Re: C.M. Christiansen Co., Inc.

SPILL RESPONSE AGREEMENT

RE: Design Report and Plan of Operation

October 21, 1998
(1226/3.8)

FIGURE NO.
2

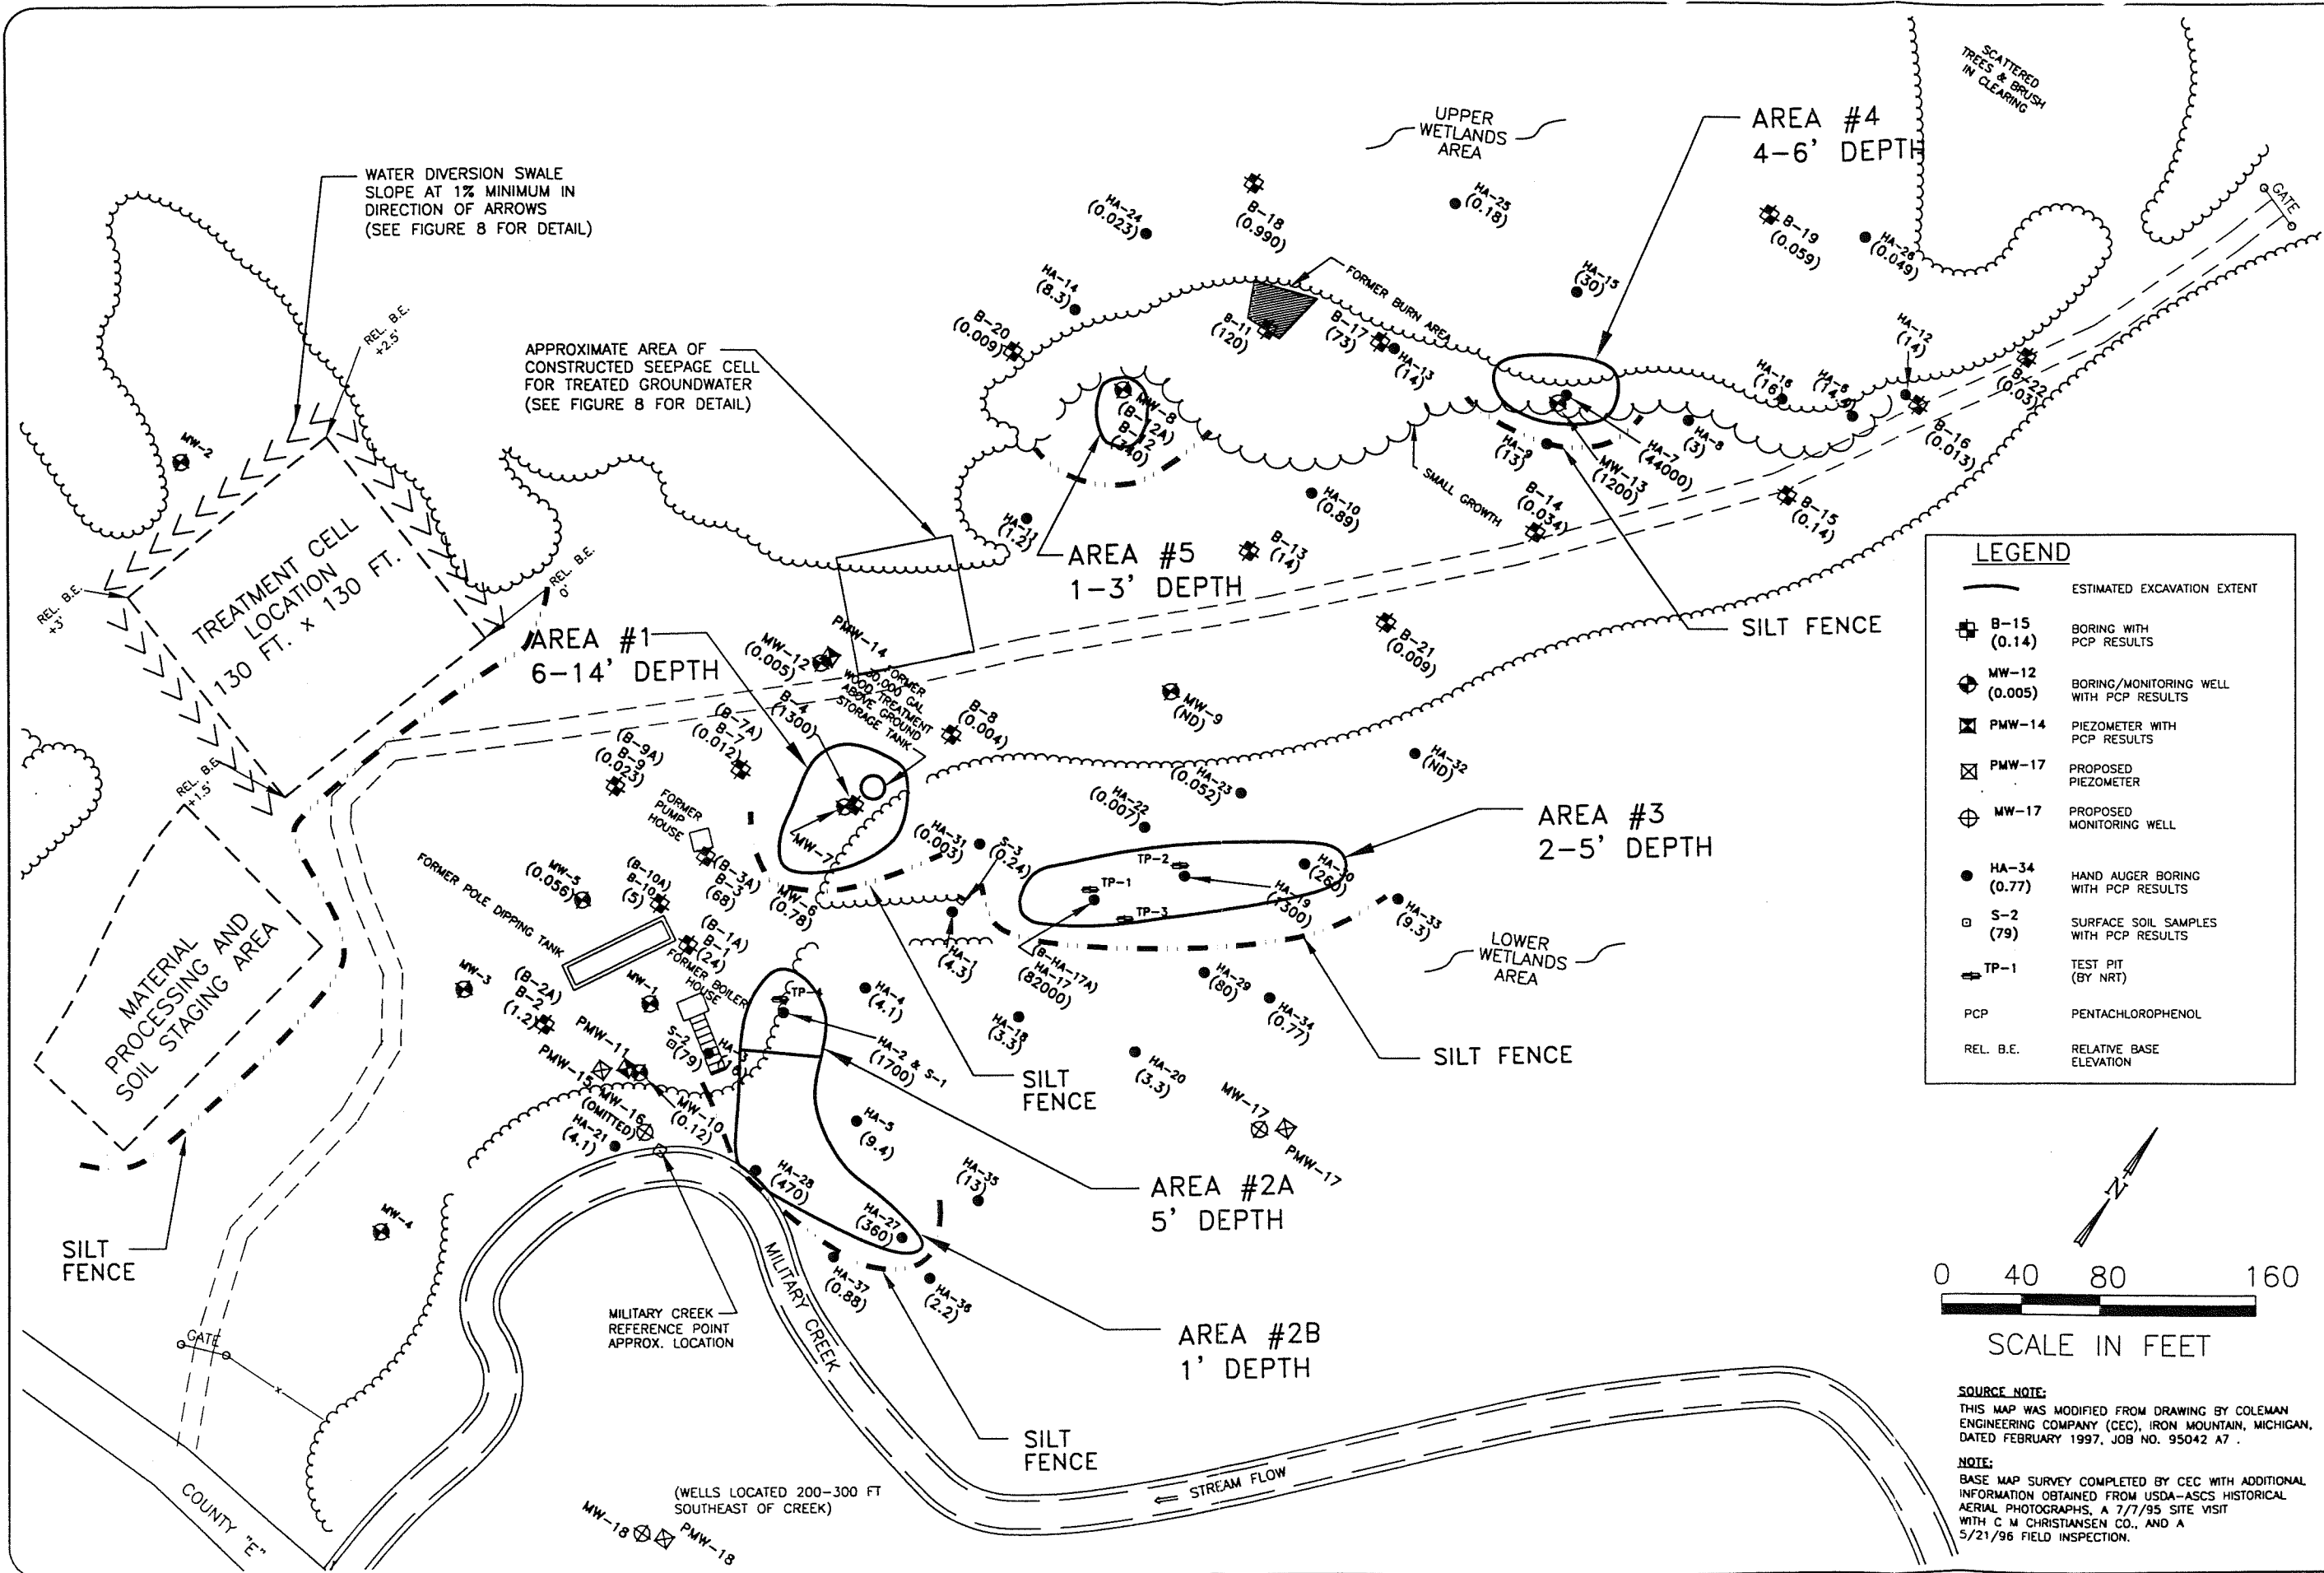
2. The soil from around MW-8 will be added to the excavation plan as requested. This modification is shown on revised Figure 2 and Table 1. The additional volume is small and should not substantially change the design plan. The MW-8 area was not included originally because groundwater data at MW-8 indicates the concentrations detected in soil at 0 to 2 feet below ground surface have not had a significant impact on groundwater. The most recent concentrations were below the NR 140 Enforcement Standard for PCP.
- 3.&4. Comments made regarding soil sampling parameters have been incorporated into Table 2.
5. Concurrent with the soil remedial action, the Department requested that CMC define the "full degree and extent of groundwater contamination, both
